From: Arch P [arch@sunflower.com]
Sent: Tuesday, February 12, 2013 6:43 AM
To: schummfoods@gmail.com; mdever@sunflower.com; hughcarter@sunflower.com; aroncromwell@gmail.com; mikeamyx515@hotmail.com; Bobbie Walthall
Subject: Retirement village and Langston heights lc

RM 12 / RM 12D Rezoning

Subject: RE: Langston Heights Addition - revised Concept Plan

RE: Langston Heights Addition
Planning Commission Agenda Items on December 10, 2012

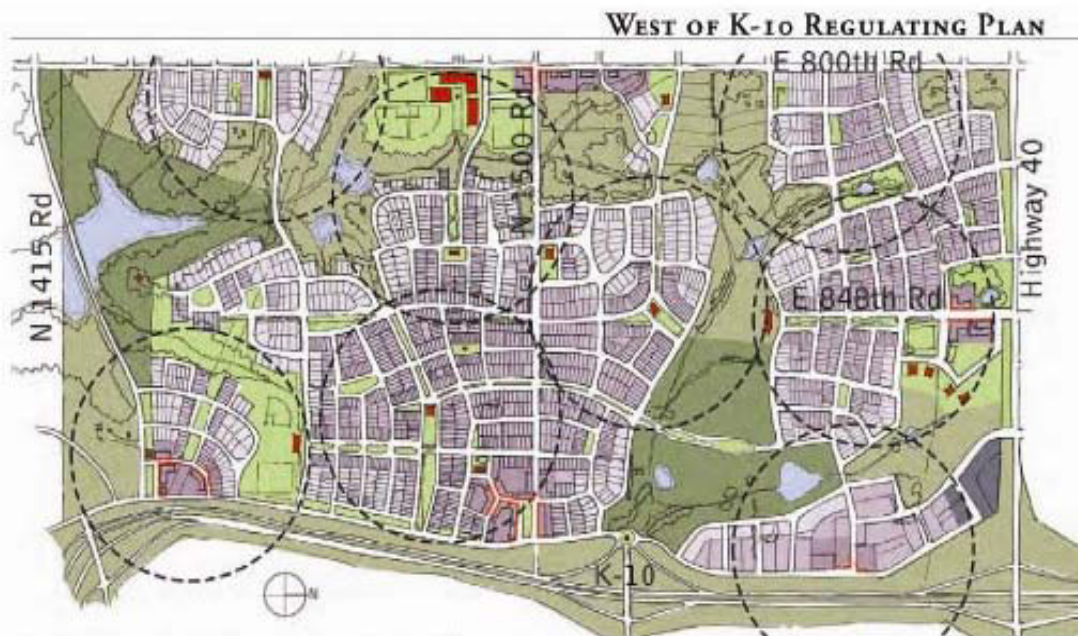
2. The Nodal plan specifically addresses the Diamondhead and Langston Heights area. The nodal plan indicates that "this intersection is envisioned as a multiple-use activity center of low-, medium-, and high-density residential development; commercial, office, research, and industrial activities; public, semi-public, and institutional uses; and parks, recreational, and green/open space opportunities." It further states for the Southeast Corner, that the corner provides an opportunity for a variety of residential, commercial, and office activities. This nodal plan "also designates the majority of its residential uses appropriate for low-

density, single-family neighborhoods with a **small** portion considered appropriate for medium-density residential development. This medium-density development serves as primary buffer between single-family neighborhoods and commercial activities.” It further states that “This nodal plan anticipates more low-density, single-family residential development in the areas surrounding this corner and therefore much of this corner was designated appropriate for similar development to maintain compatibility of surrounding land uses.” The staff report quotes specific sections but fails to address the statement “appropriate for low-density, single-family neighborhoods.” It only constantly quotes “a mixture of housing types... should be encouraged.” We do not dispute the need for a mixture of housing types, but the question is whether this proposal is the correct mixture or the correct location? The developer and applicant admitted at the neighborhood meeting that this type and mix of development “has not been tried or developed in Lawrence.” Why is this established successful neighborhood the place to try this experiment?

Figure E - Pre-determined zoning plan

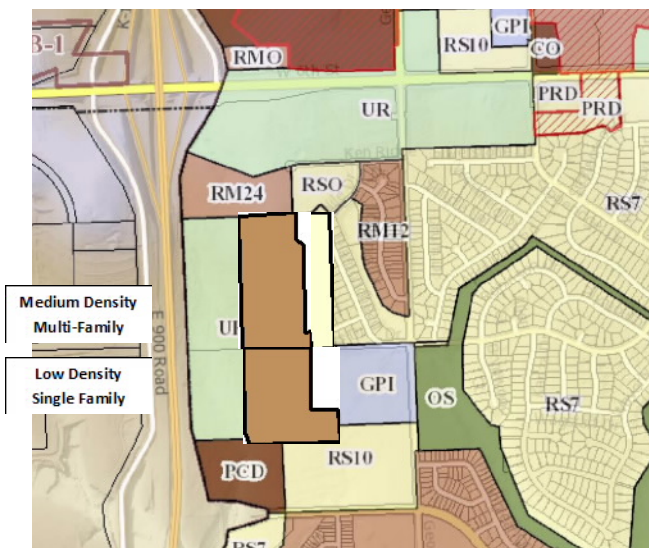
The map at left indicates the pre-determined extent of the southern land and, the quantity of medium density zoning, is counter to the current adopted land use documents.

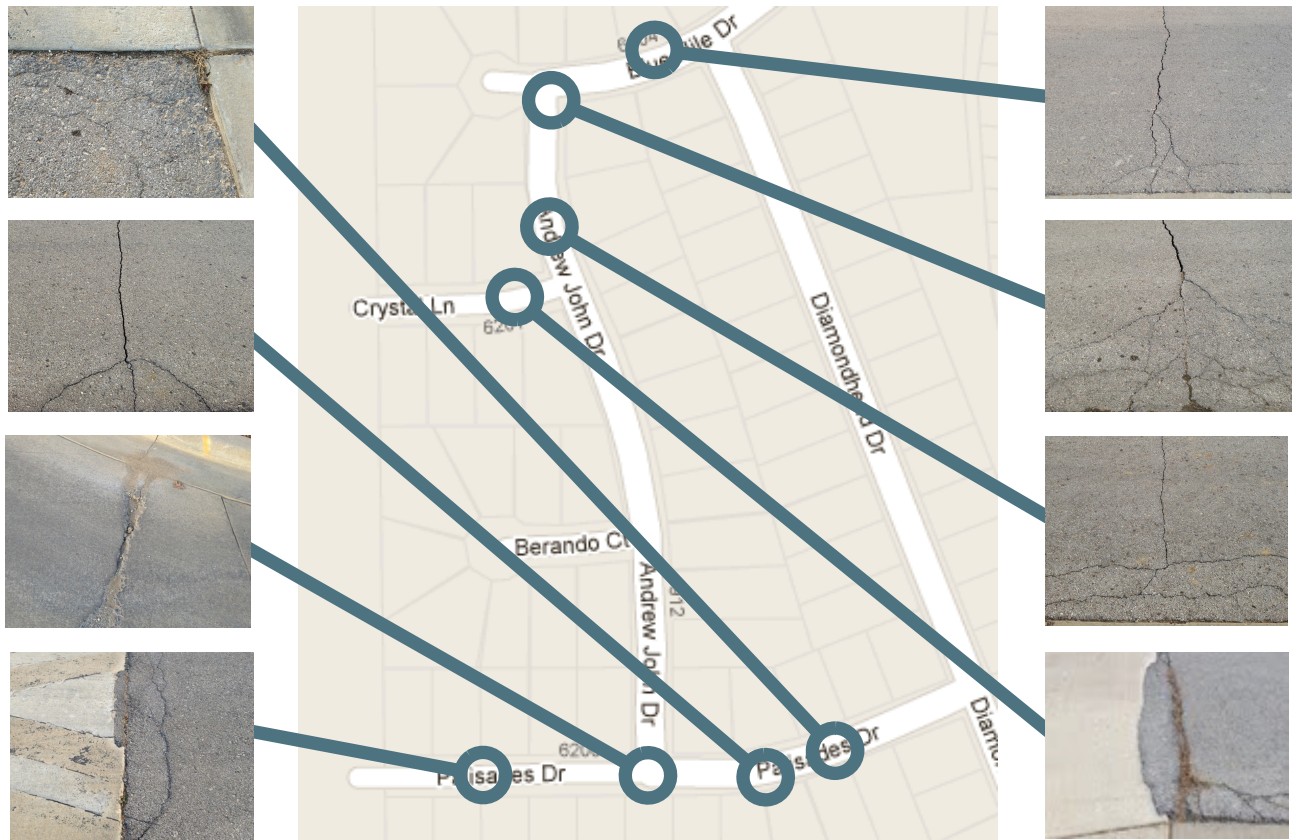
None of the intersections in the community feature traffic signage. The applicants count at least 138 additional trips per hour with the traffic study, but fail to demonstrate its effect within the existing layout. We have already discussed the potential for pedestrian accidents, but the limited sight-lines and lack of any stop or yield signs is an invitation to traffic accidents.

The streetlights throughout the area have similarly been installed for use in single family housing. The inclusion of additional multi-family housing could be cause for increased lighting. The residents of the area however are not keen on the idea of the additional lighting shining through their windows all night.
